GEORGETOWN-SCOTT COUNTY PLANNING COMMISSION
AGENDA

February 12, 2015
6:00 p.m.

EVERYBODY'S AUTO SALES
Staff Report to the Georgetown-Scott County Planning Commission
February 12, 2015

Staff Report to the Georgetown-Scott County Planning Commission February 12, 2015

PRELIMINARY AMENDED DEVELOPMENT PLAN

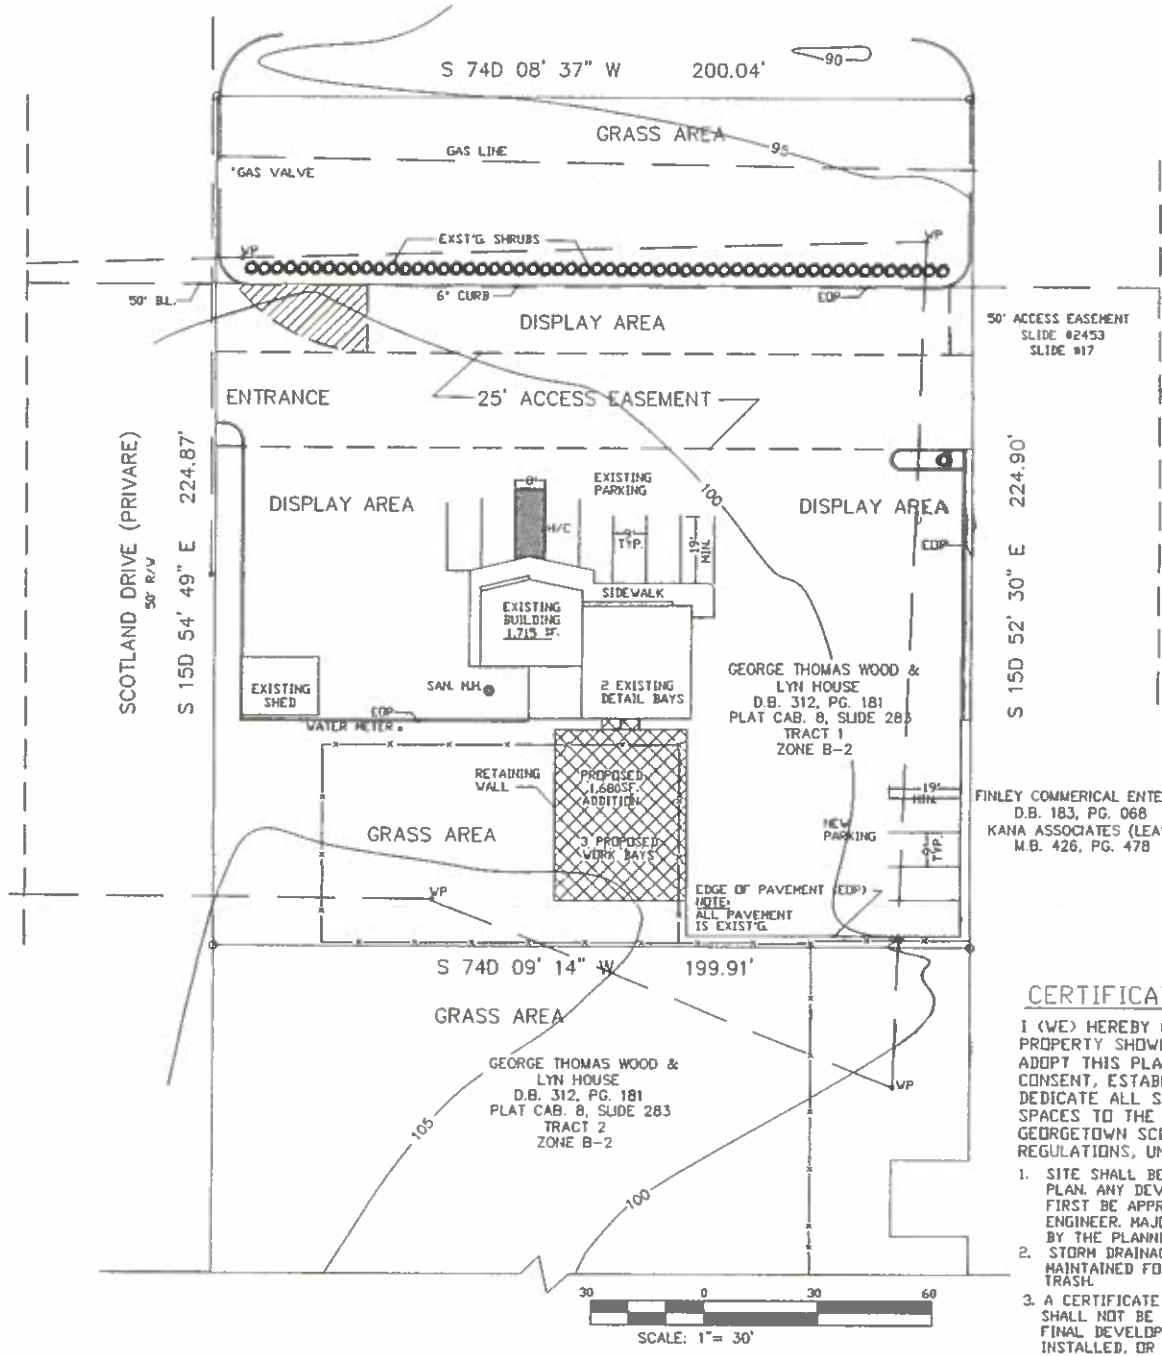
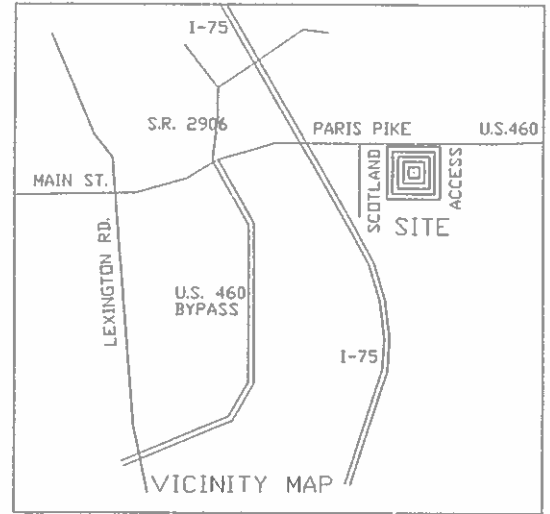
- 1) Striped parking was called for in the previous plan. Currently, only the customer parking areas are striped. Applicant seeks to continue with only striping the 6 spaces in front of the main building and 4 new striped spaces in the southeast corner of the lot's existing paving.

- 2) The previous plan stated that no more than 26 vehicles would be displayed at any given time. Staff has been told that more than 26 vehicles can be (and have been) displayed on site.

- 3) There is an access easement shown on the development plan submitted with application FDP-1999-68. The applicant would like to remove this easement. They have stated (as in FDP-1999-68) that even though the area is closed off by a cable to discourage cut-through traffic, this would not impact the fire department if they needed to utilize this point of access. Staff prefers that the easement remain, as it provides access if uses and needs change. In order to remove the easement, a plat would need to be recorded, not just discussion or approval by Planning Commission as part of the Development Plan review. Staff recommends that the Fire Department be consulted.

- 4) A condition was placed that "The detail shop shall be limited to detailing activities and topping off of fluids only." The applicant asks that this condition no longer apply as they are currently conducting more intensive auto repairs on site, as allowed within the standard B-2 regulations.

No vehicle use area/lot expansion is planned at this time. However, staff notes that the existing parking lot is larger than what was previously approved by FDP-1999-68. It appears the lot was enlarged at some point, although no more recent project files have been found. This development plan does show four new striped parking stalls on the southeast portion of the existing paving.

With the addition of the new work bays, some parking on site will be lost in order to allow for circulation and access to these bays. It is staff's recommendation that clearer delineation of customer parking areas be provided to assist customers and enforcement of the condition that customer parking spaces should be striped as shown on the Final Development Plan.

Because the parking lot expansion was not approved or previously reviewed, in addition to the storm water calculations for the new building area, the applicant will also need to include calculations for total impervious area including the parking area not shown in PDP-1999-68. If there is not adequate space on this site to accommodate storm water management, an off-site solution can be coordinated on the adjacent parcel south of the lot under the same ownership. This will be required as part of the Final Development Plan.

1. A survey of the rear lot line shall be conducted prior to Final Development Plan submission.
2. The final location of the building addition will require approval from Kentucky Utilities regarding proximity to the existing utility pole and wires.

10. A Final Stormwater Management Plan must be submitted and approved by the Planning Commission Engineer prior to approval of the Final Development Plan.

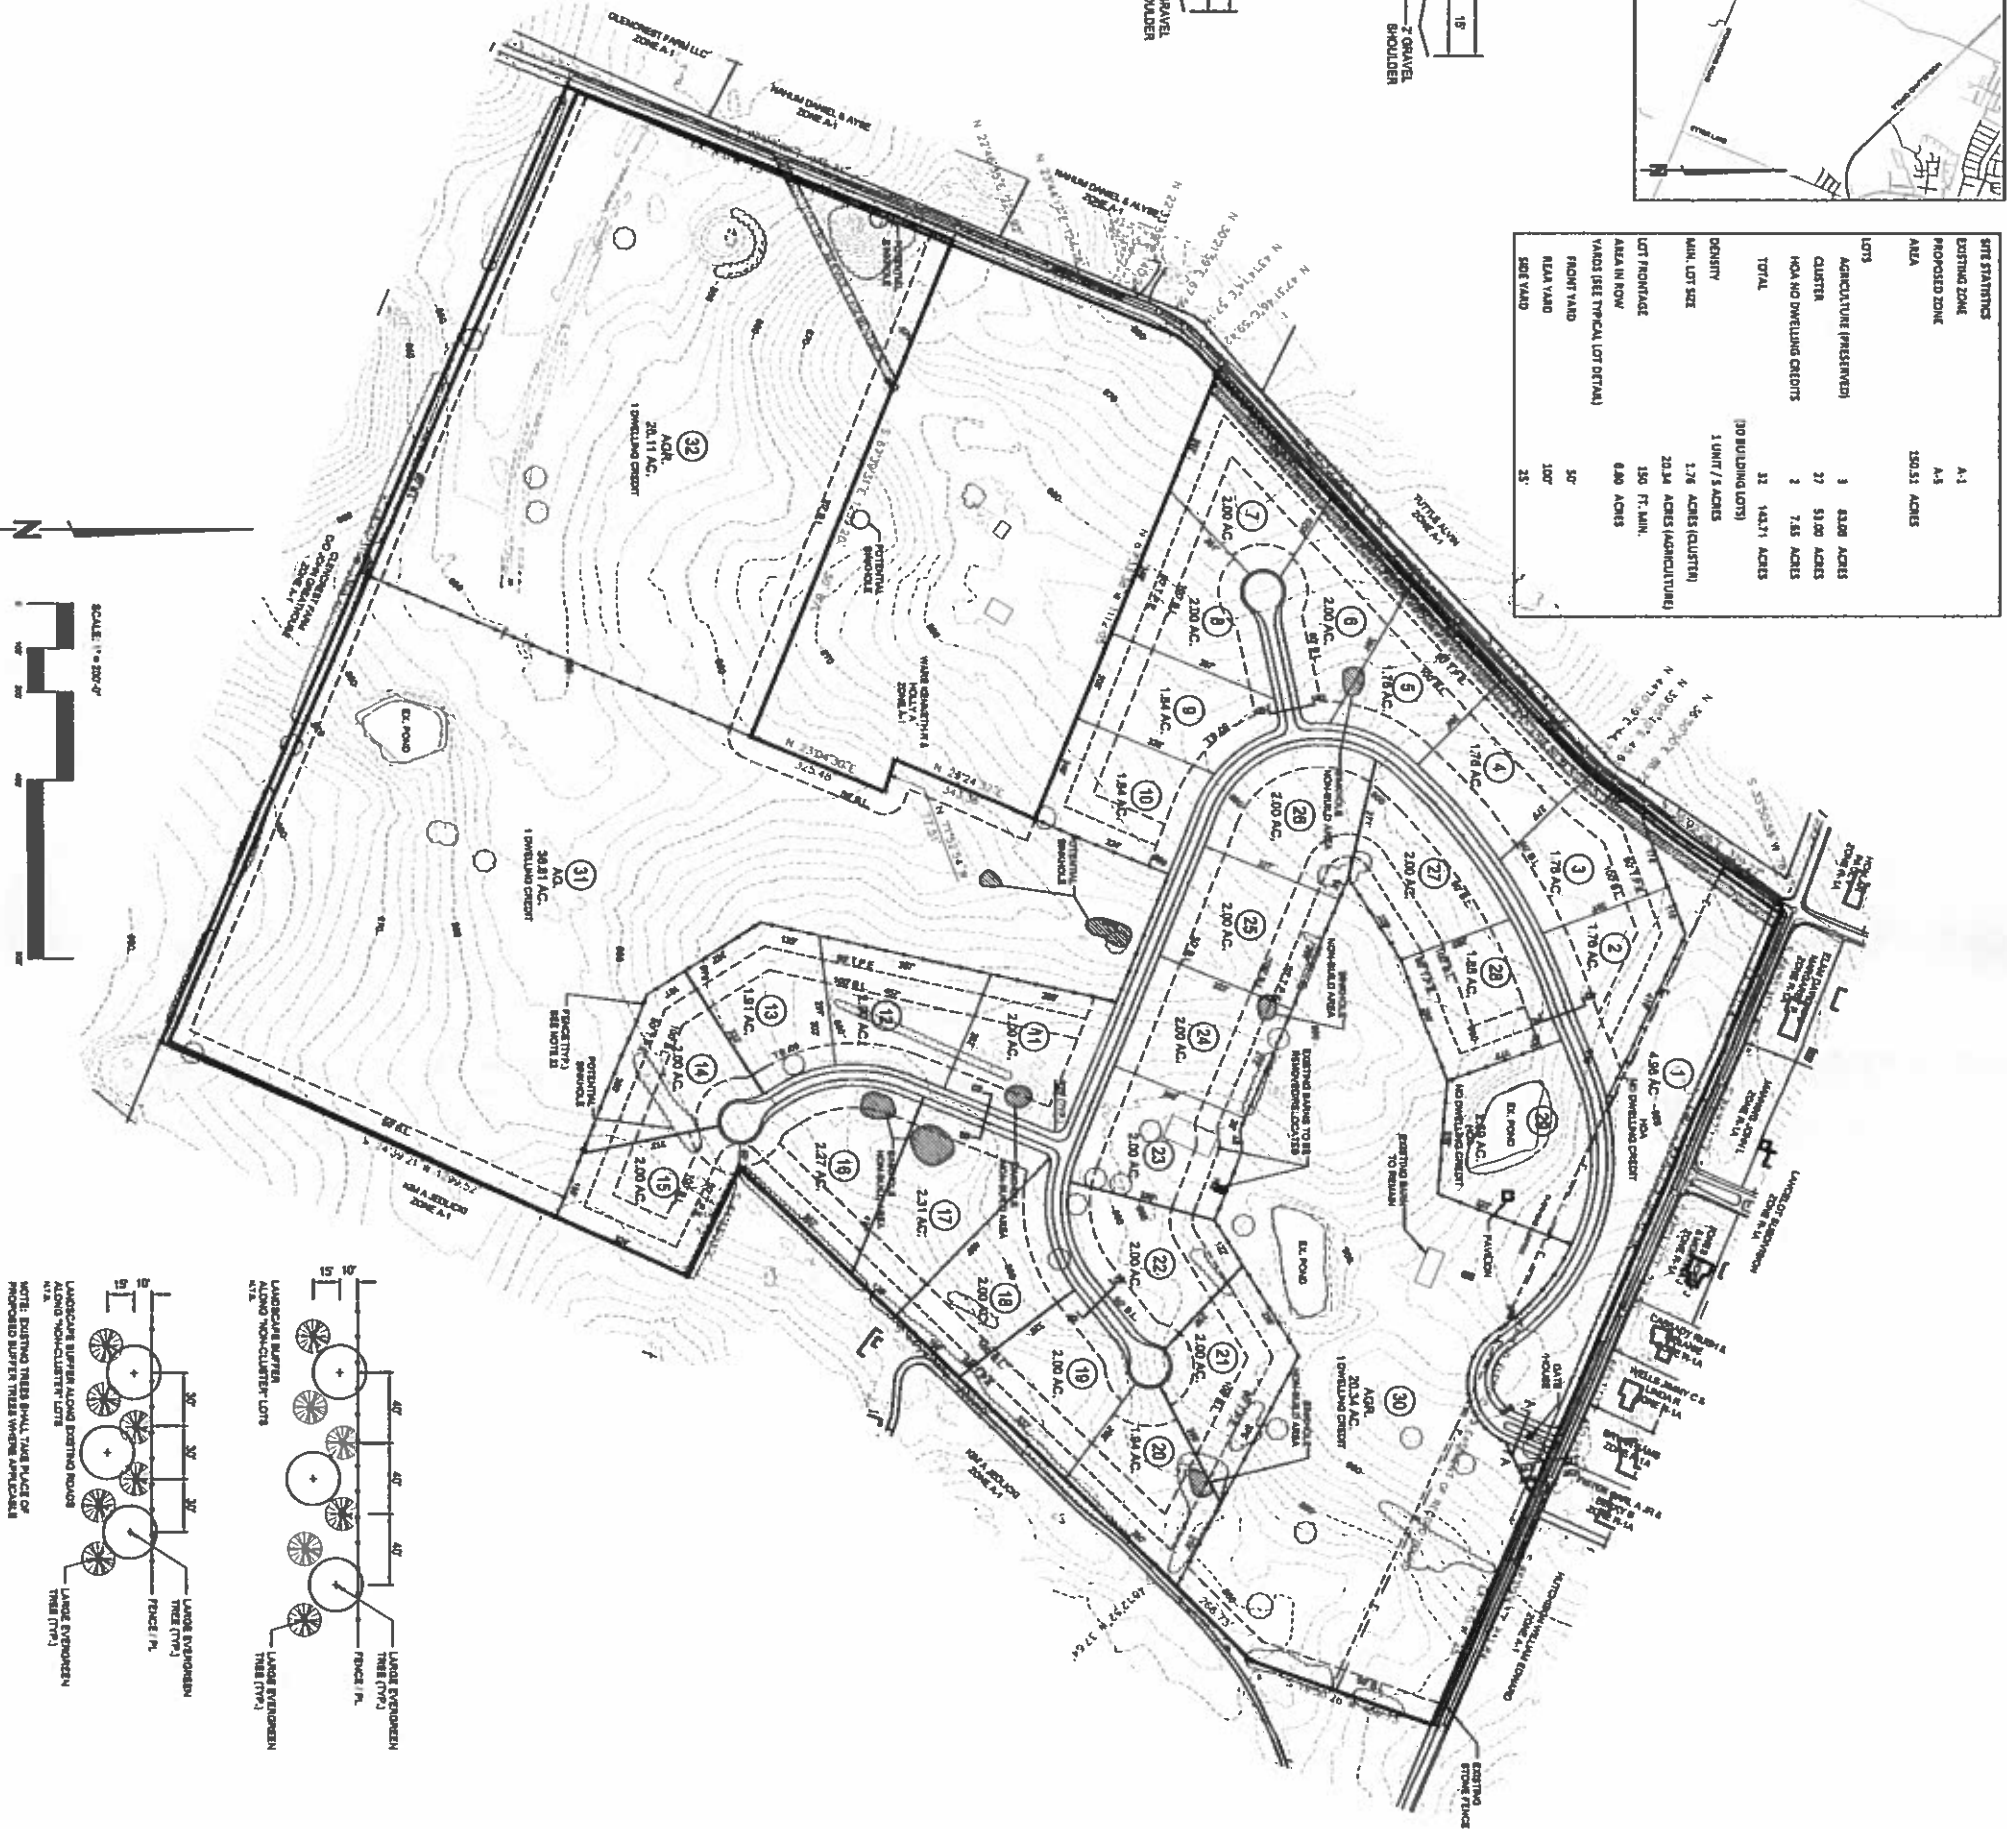
2. Where cluster lots about an existing road, trees shall be required on 30' centers along the existing road frontage of the cluster lots. The ratio of evergreens and deciduous trees should not exceed 2:1: **All requirements are addressed on plan.**

6. Cul-de-sacs: Cul-de-sac geometry shall conform to the requirements contained in Appendix VII. Alternative cul-de-sac designs may be allowed where approved by the Fire Chief and the Commission Engineer/Planning Director, so long as all lots have sufficient and safe access for emergency vehicles: **Proposed cul-de-sac designs will be reviewed at construction plan submittal.**

Z. Existing stone fences may not be removed or altered except where the proposed road is to be installed, including the required sight triangle: **A stone fence exists on the site and runs along Ironworks Road. Fence preservation plans must be approved by Planning Commission staff prior to Final Subdivision Plat approval.**

4. No cluster lots may directly access Ironworks Road.
5. Provide a species specific landscape plan with the Final Subdivision Plat.
6. Note Scott County Road Acceptance Policy on Final Subdivision Plat.

7. Final entrance location shall meet separation and sight distance requirements and shall be approved by the Planning Commission Engineer.
8. Note must be added to Final Subdivision Plat stating the minimum requirements of #9 wire mesh and posts spaced on 12' centers. Fencing must be shown around entire cluster development: Lots 1-21. (Note: fence must be installed prior to Final Subdivision Plat approval and cannot be bonded.)

13. Note maintenance agreement for roads, right-of-way, and any drainage structures on Final Subdivision Plat.
14. Stone fence preservation plans must be approved by Planning Commission staff prior to Final Subdivision Plat approval.

LIVE MAS
MEDIUM54
PRELIMINARY OVERALL SITE PLAN
C1.1

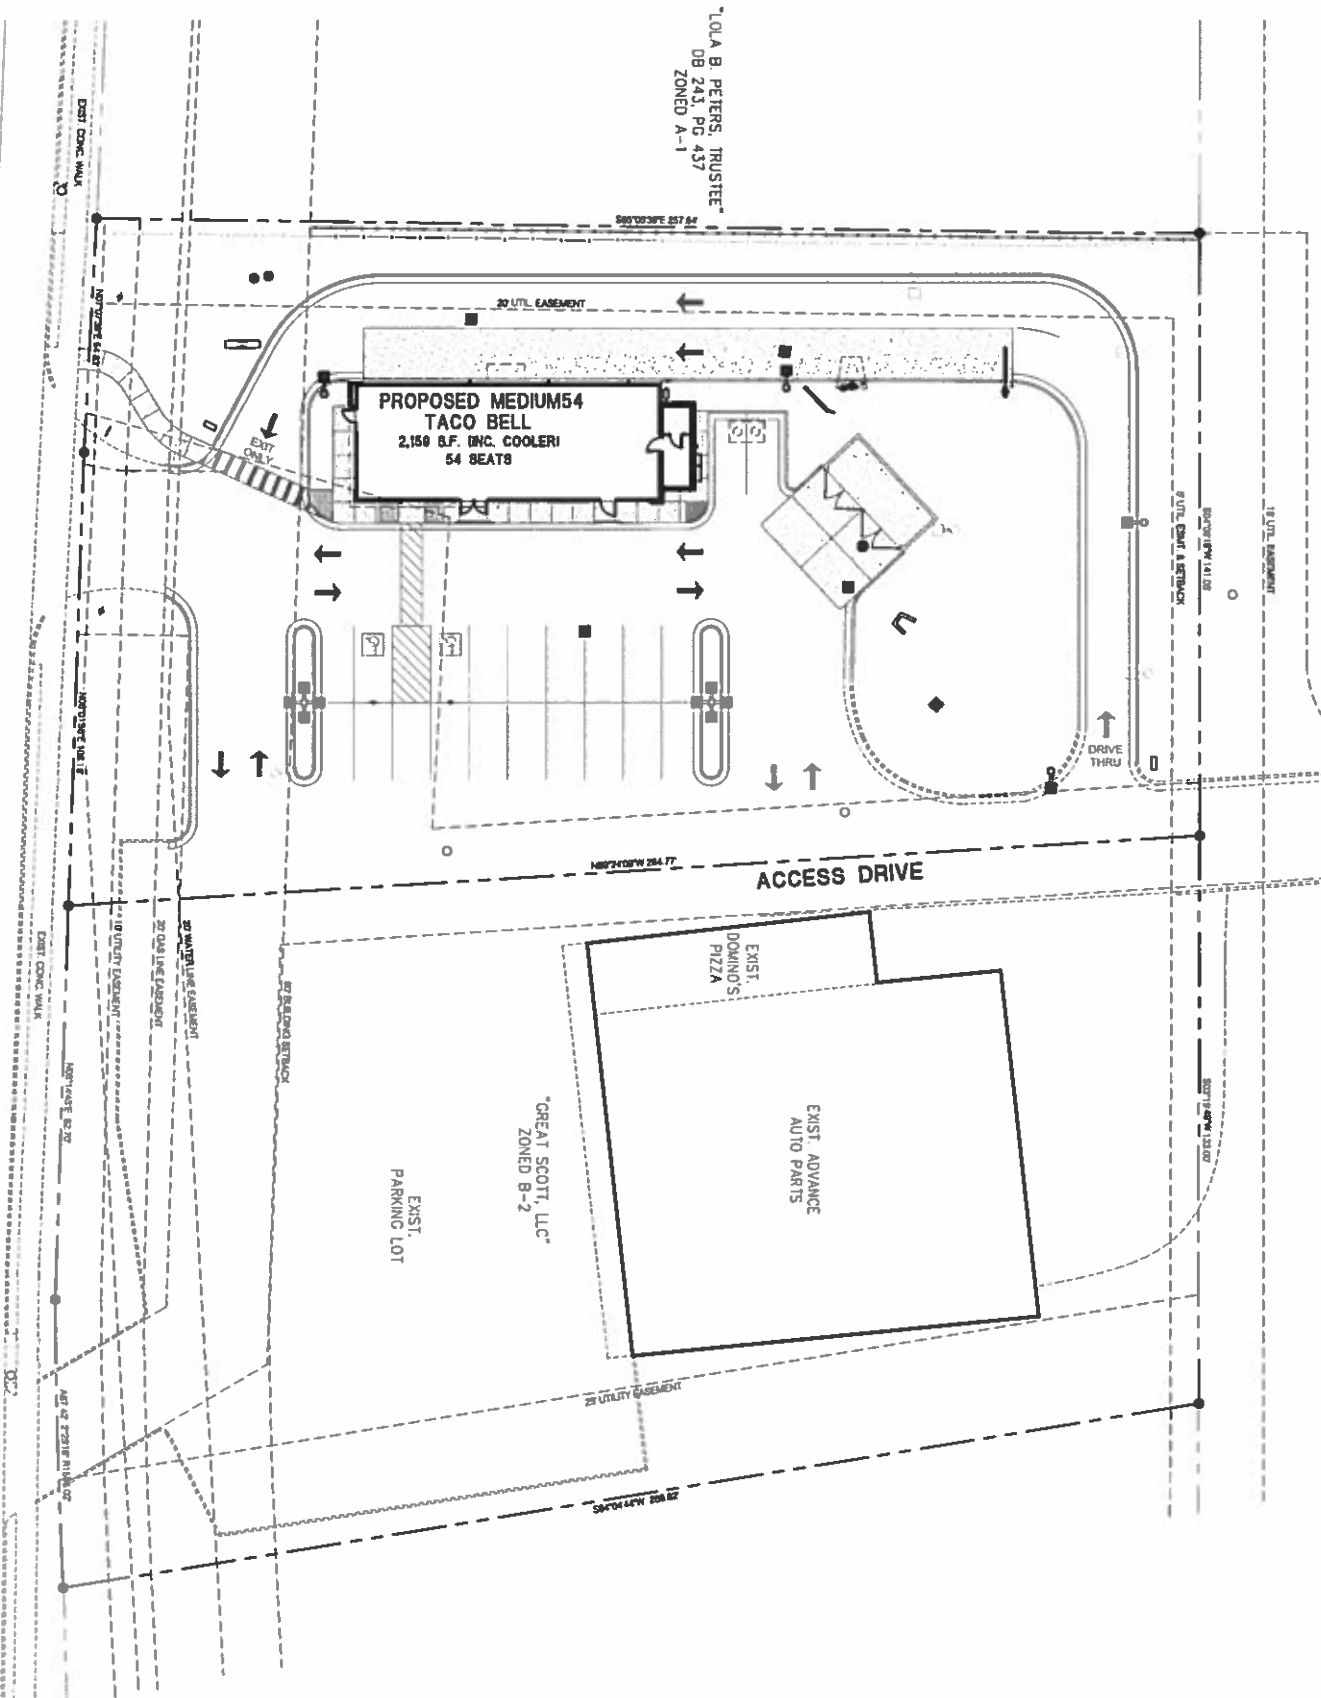
There is an existing entrance serving this commercial area from US 25 (Lexington Road) The entrance serves multiple lots and an access easement is in place for public access to the multiple lots. The circulation on site is a concern, particularly truck delivery traffic and emergency access utilizing the Taco Bell entrance and having to navigate the sharp turn proposed in the Taco Bell plan. The proposed radius and relocated driveway would make it difficult for emergency vehicle and large trucks to enter from Lexington Road and navigate the access road. The existing easement cuts through an area that is proposed for parking on the new plan. One way to address this issue is for Taco Bell to require all of their truck delivery traffic to enter from the rear of the site. Large fire trucks could still enter the site from the front but would have to enter straight and block the parking lot drive aisle.

No shared parking arrangement is required. However, it is recommended that pedestrian access from the sidewalk along Lexington Road to the front door of the proposed Taco Bell be provided. It is recommended that all truck deliveries use the rear entrance. A shared access and maintenance agreement for the private access easement shall be provided prior to Final Development Plan approval. It is also recommended that a bike rack be provided, as the site is between a large residential area and a public park and recreational area and the adjoining roadway contains a bike lane. Bike traffic can be reasonably expected.

A master sign plan should be submitted along with the Final Development Plan to coordinate signage and to assure that sign design meets the requirements of the Sign Ordinance and can be permitted without delays. It is recommended that a monument sign be used due to the overhead utilities and the elevation of the site above the adjoining roadway.

4. A sidewalk connection shall be provided from South Broadway to the building entrance.
5. A lighting plan shall be submitted with the Final Development Plan.

6. The access easement shall be amended to reflect the realigned shared access drive prior to Final Development Plan approval.
7. The Final Development Plan shall meet all requirements of the Health Department.
